ADDENDUM NO. 2

March 1, 2022

**TIMOTHY BALL ELEMENTARY SCHOOL ADDITIONS, RENOVATIONS,
AND RELATED WORK
Crown Point, IN 46307**

This Addendum forms a part of and modifies the Bidding Requirements, Contract Forms, Contract Conditions, the Specifications, and the Drawings dated February 7, 2022 by Gibraltar Design. Acknowledge receipt of the Addendum in the space provided on the Bid Form. Failure to do so may subject the Bidder to disqualification.

B MV103

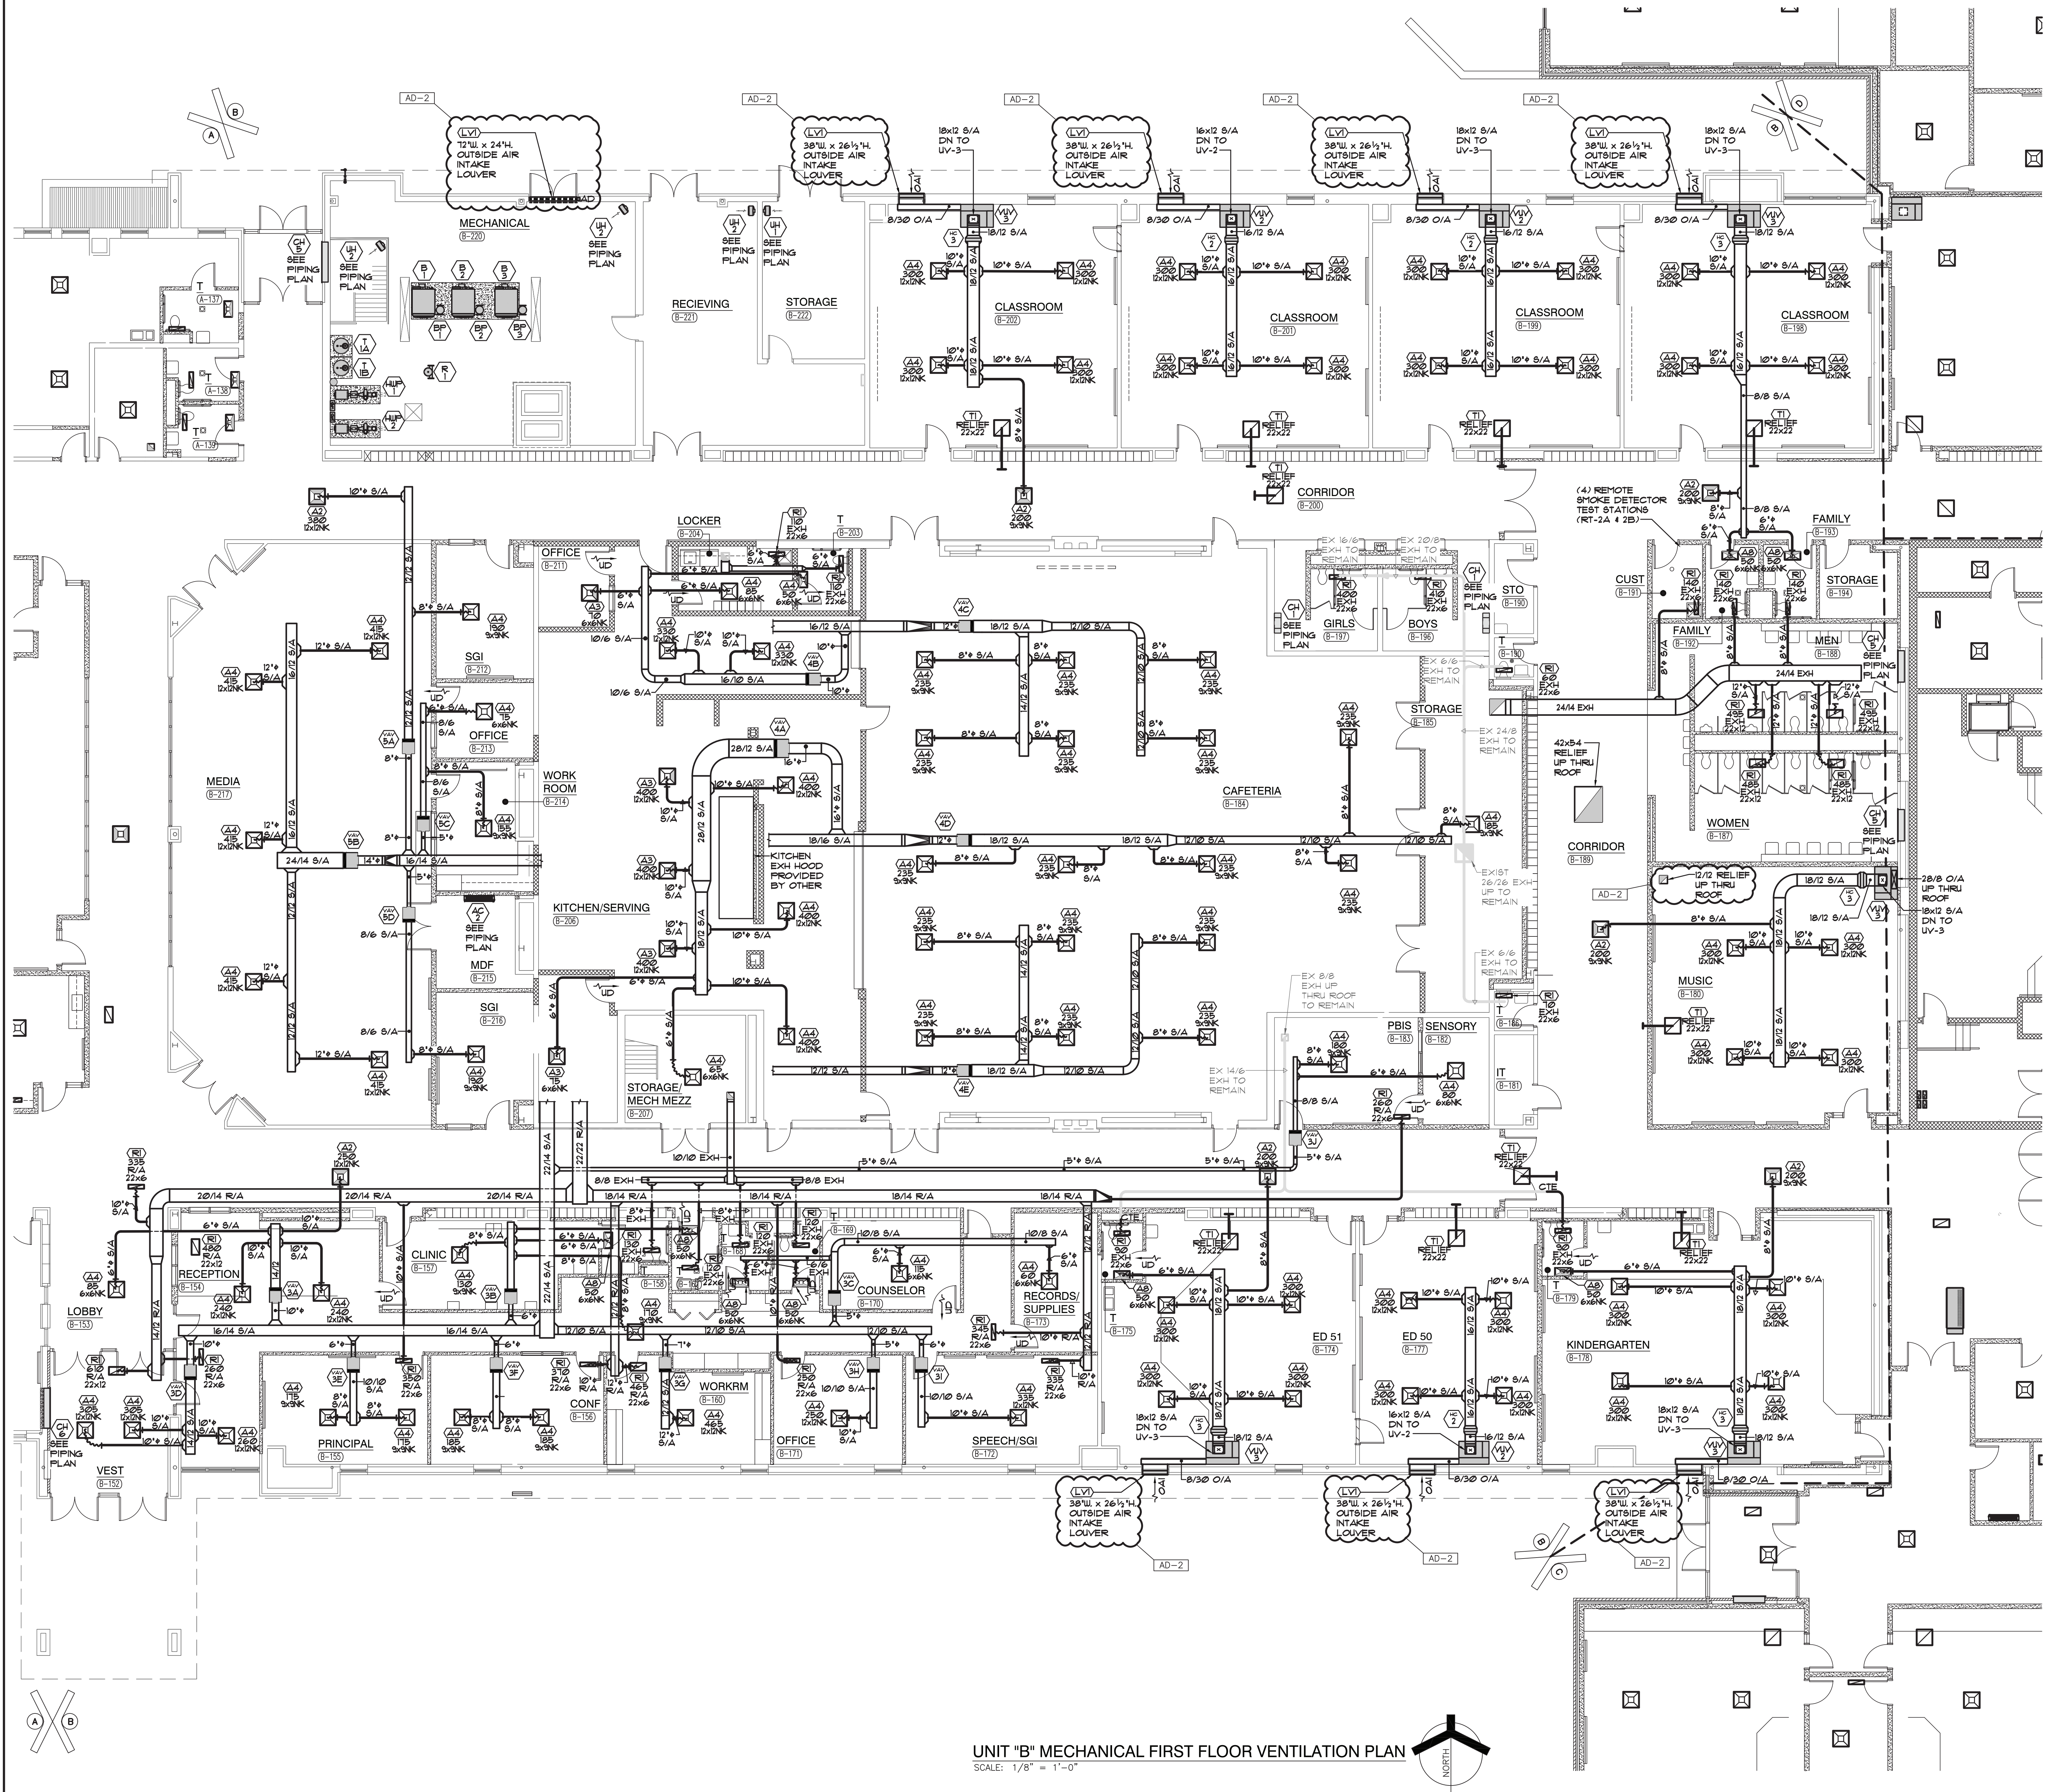
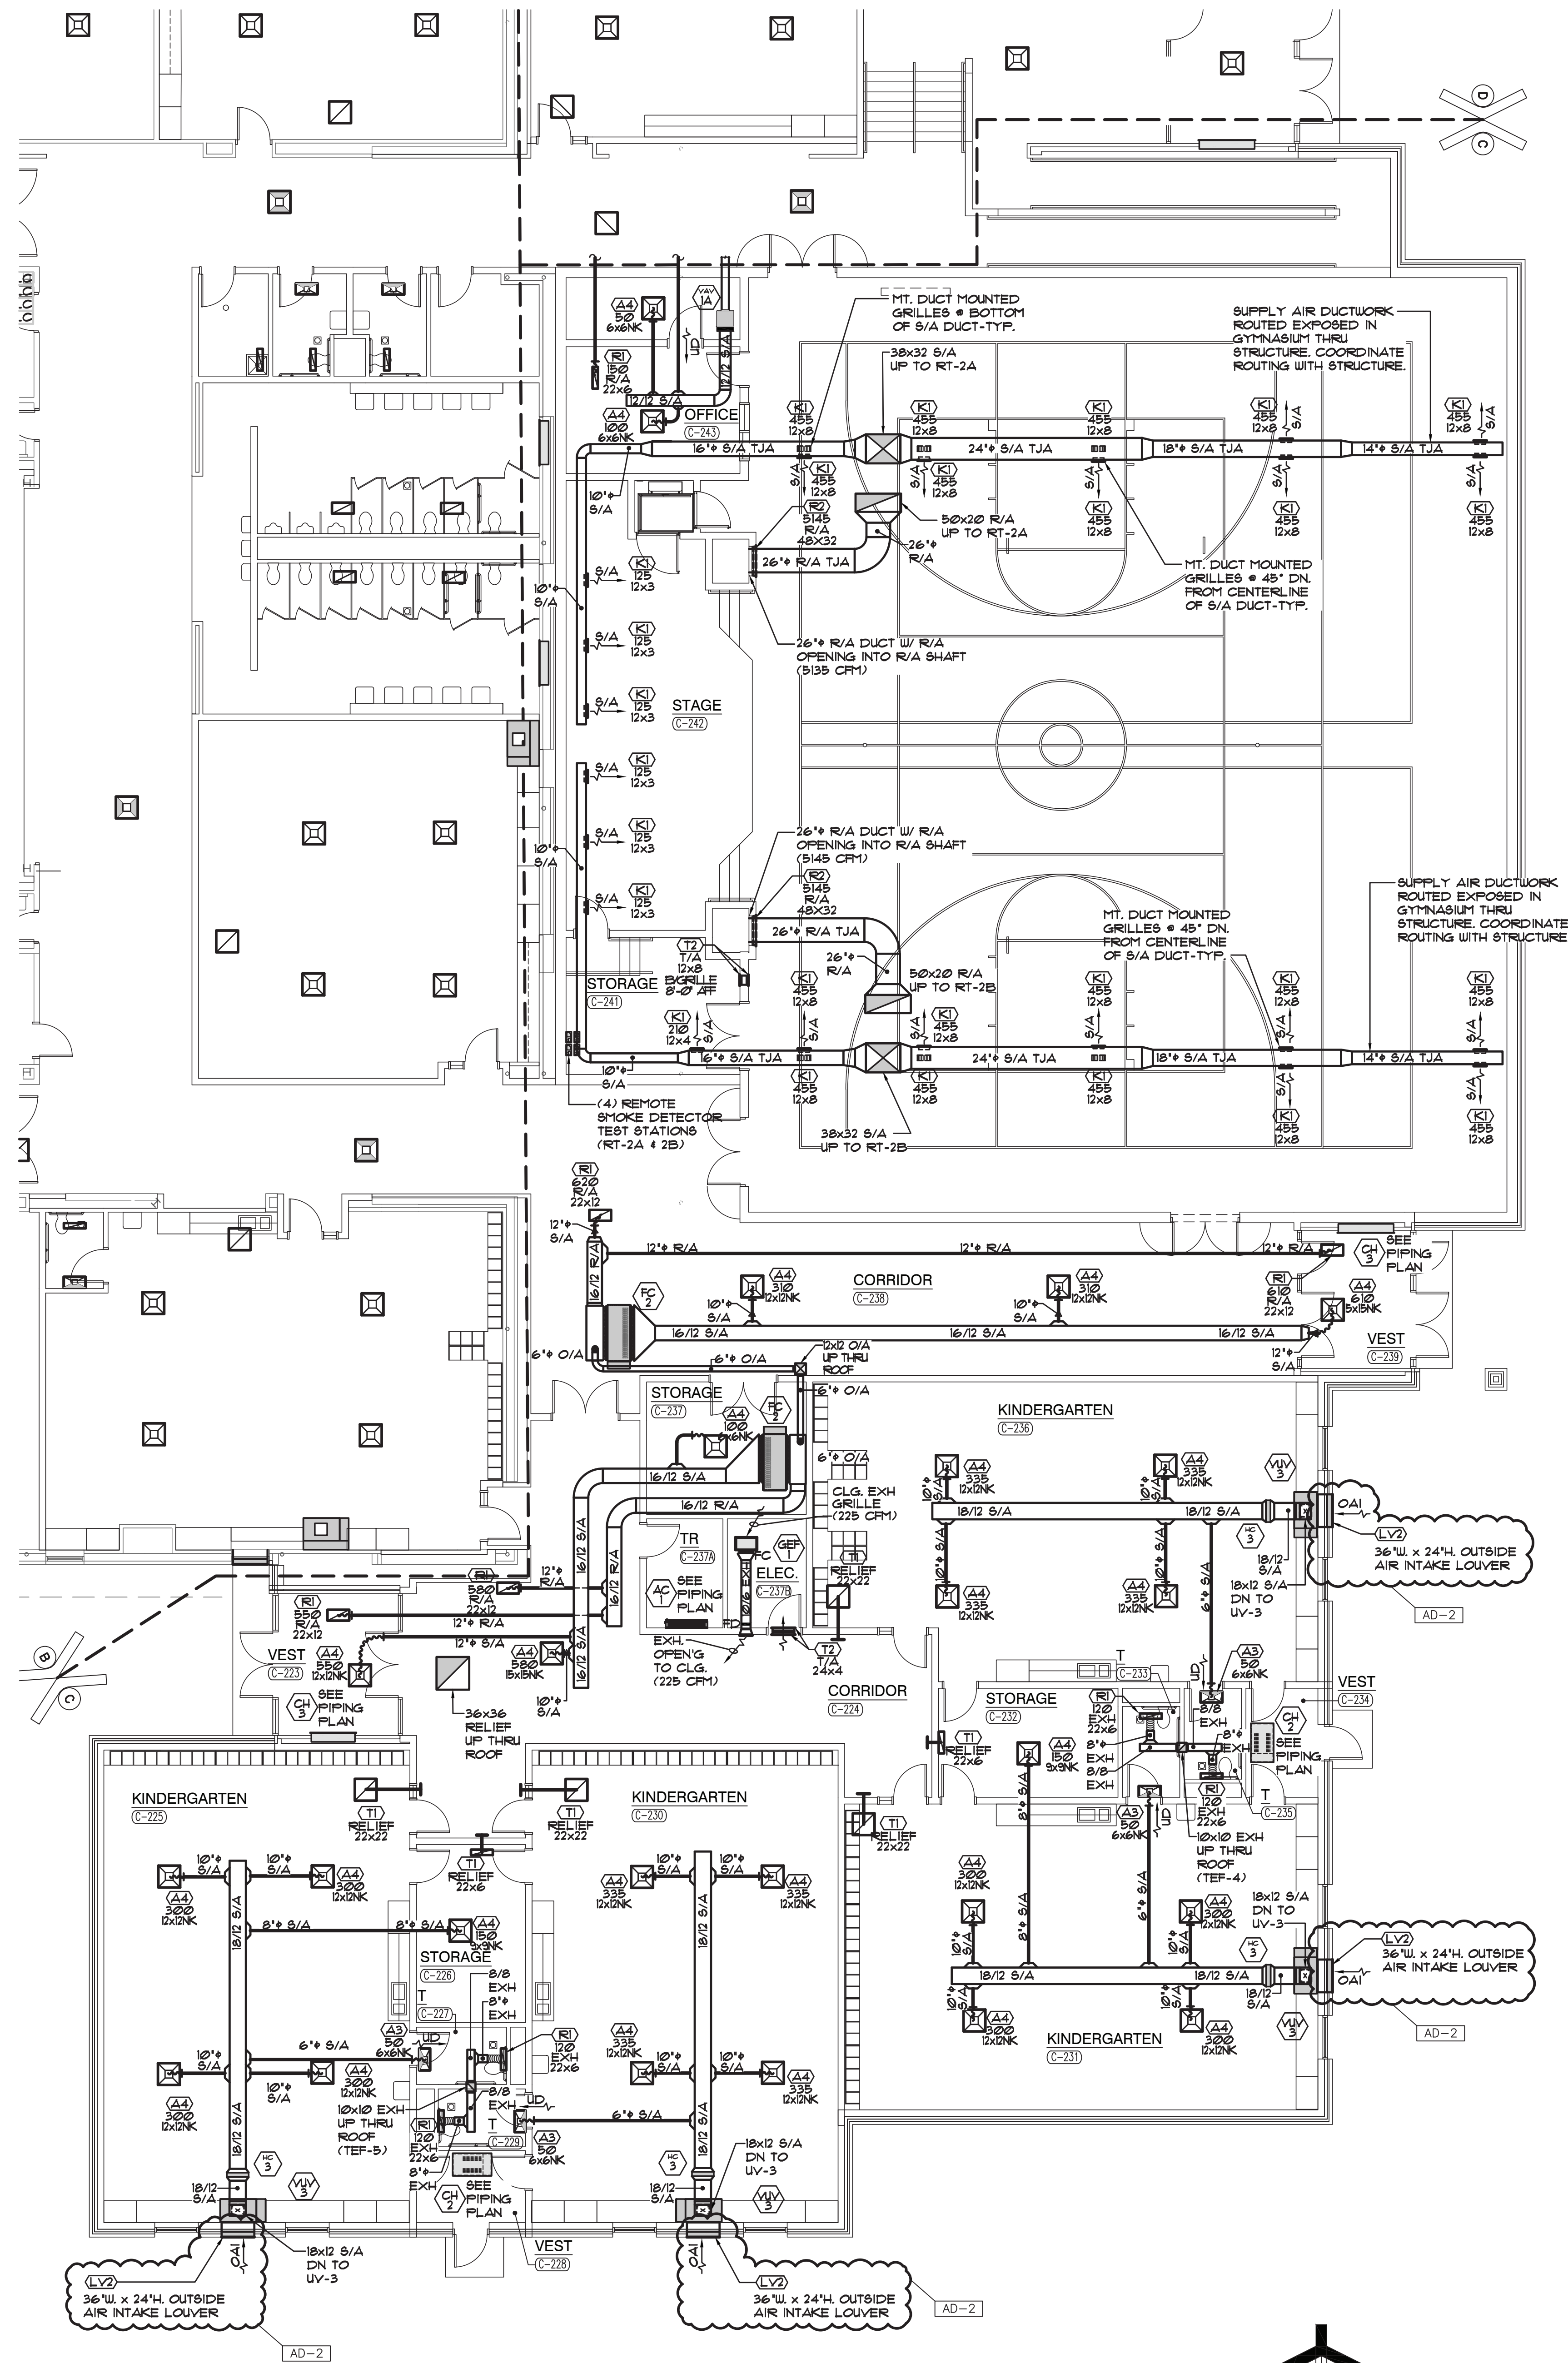
26. Sheet MV103

- A. Refer to revised, full size drawing, included in this Addendum, for the following revisions:
1. Revised louver size to 38"w x 26½"h in Classroom B-198, B-199, B-201, B-202, ED51 B-174, ED 50 B-177, and Kindergarten B-178.
 2. Added 72"w x 24"h louver to Mechanical B-220.
 3. Clarified relief up thru roof in Music B-180.

© GIBRALTAR DESIGN
D MV105

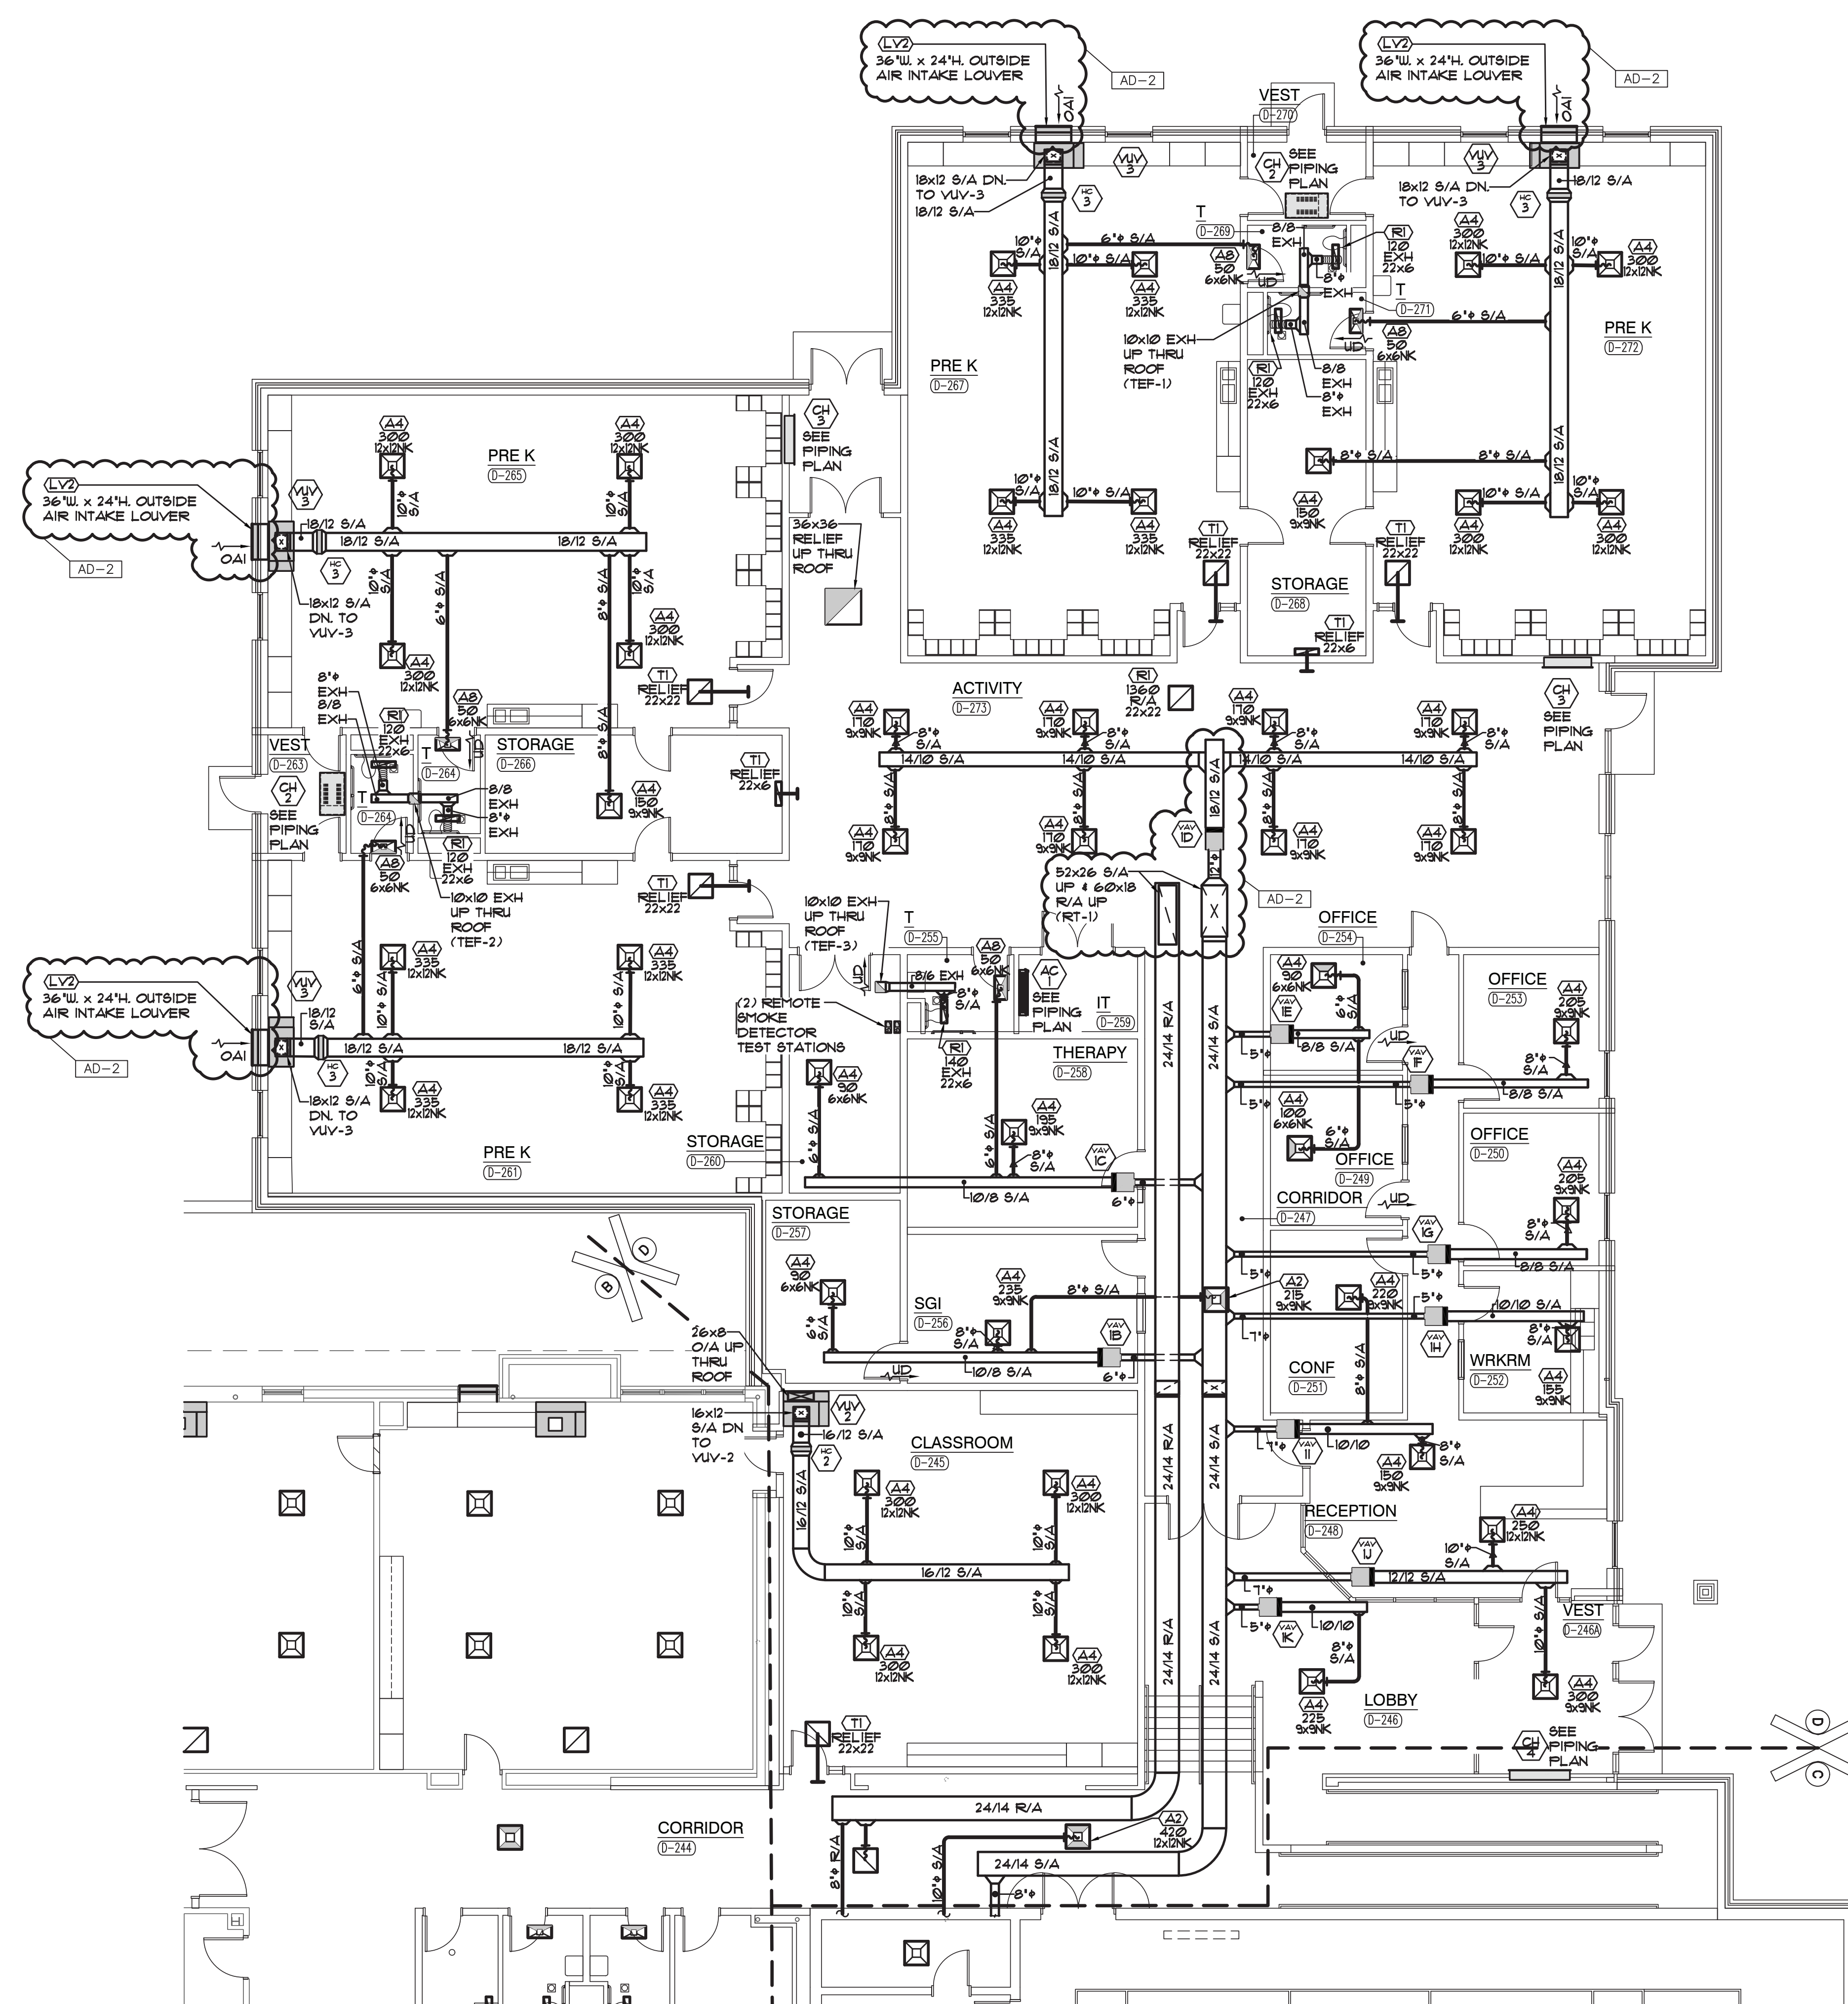
28. Sheet MV105

- A. Refer to revised, full size drawing, included in this Addendum, for the following revisions:
1. Revised louver size to 36"w x 24"h in Pre-K D-261, D-265, D-267, and D-272.
 2. Removed blank-offs on louver in Pre-K D-261, D-265, D-267, and D-272.
 3. Revised location of duct rises and tap offs for RT-1.
